Note for reader

This document provides an initial proposal/structure for adding a new optional Low Temperature (Type 6) test to GTR15.

**Amendment 5 to UN GTR No. 15 (Worldwide harmonized
Light vehicles Test Procedures (WLTP))**

Figure A6/1

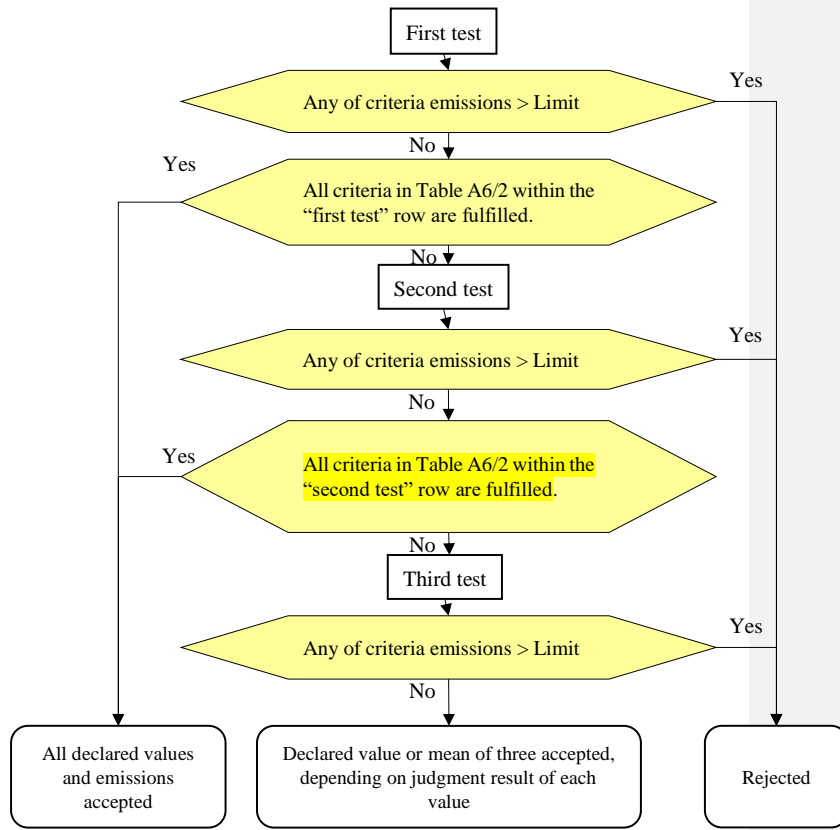
2.6.1. ~~xxx~~Figure A6/1 shall be understood as follows:

AMEND TABLE A6/2 TO REFER TO JUST CRITERIA EMISSIONS –
DELETE COLUMNS FOR CO2 and EC
